DraftPreliminaryHRSC_CSM_FID_082416_TowerStandard
Author: Jason C. Ruf
Organization: S2C2 Inc.
Description: Draft CSM for High Resoluti...
Tower Standard Site
Lac du Flambeau, Wisconsin
Data Analysis and Data Visualization Report
August 2016
Vertical Exaggeration is 2.5x
MIP-FID above 50,000 uV
Elevation
MIP-FID
10,000,000 uV
3,000,000 uV
1,000,000 uV
300,000 uV
100,000 uV
30,000 uV
10,000 uV
Total VOCs
1,000,000 ug/kg
300,000 ug/kg
100,000 ug/kg
30,000 ug/kg
10,000 ug/kg
3,000 ug/kg
1,000 ug/kg
300 ug/kg
100 ug/kg
30 ug/kg
10 ug/kg
3 ug/kg
1 ug/kg
1,990,400
1,990,500
Inbox - Mailbox - Kady, Tom - Outlook
You are not responding to the latest message in this conversation. Click here to open it.
To... Egan, Robert
Subject RE: Recommendations for additional well locations at the Tower Standard site
Hi Bob – I've included below in red some of the logic and additional details from our discussion on the proposed monitoring well locations. I believe this information will help to provide some boundary conditions to improve the accuracy of the 3D data visualization and to help provide a reliable basis to quantify the mass distribution of contaminants across different response ranges with MI

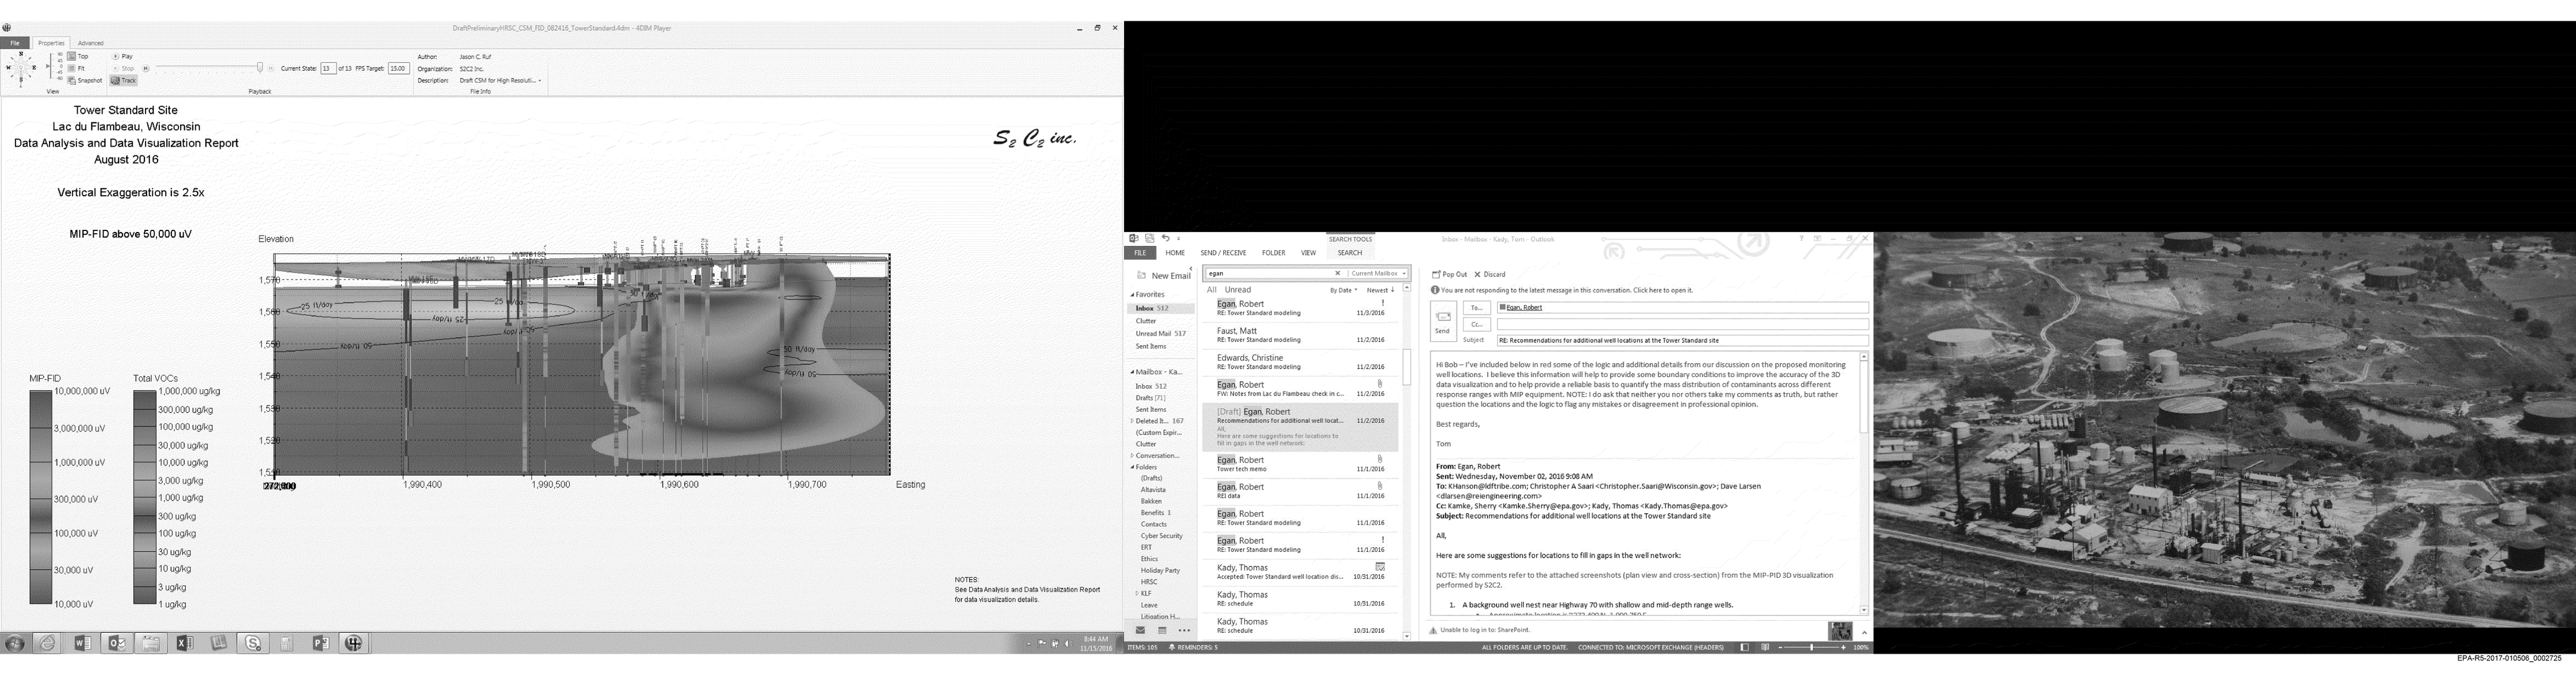
1. A background well nest near Highway 70 with shallow and mid-depth range wells.
Unable to log in to: SharePoint.
ALL FOLDERS ARE UP TO DATE. CONNECTED TO: MICROSOFT EXCHANGE (HEADERS) 100%
